Report 1

Report 2

Inter-comparison and evaluation of Arctic sea ice type products

By Ye, Yufang, et al.

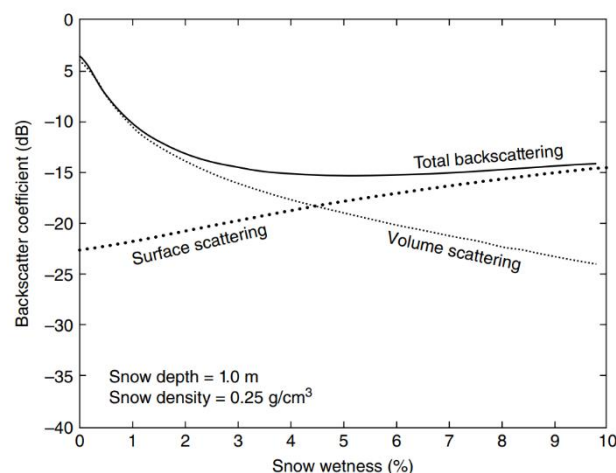
L610: Have you looked at MYI ice cores? Did you find air bubbles of 2 cm diameter? I think this is an order of magnitude too large. I suggest that you dive into papers / book chapters describing ground- or air-borne active microwave measurements over different ice types and attempts to understand the reasons for the observed differences. The book Microwave Remote Sensing of Sea Ice by F. D. Carsey might be a good source - as well as papers dating back to the 1980s.

Reply: Thank you for the question. We read the books and references as suggested. It shows as the reviewer comment, that it is an order of magnitude too large. In the revised manuscript, we modified the sentence as below:

“This could be due to the fact that Ku-band scatterometer is more sensitive to the volume scattering in MYI.”
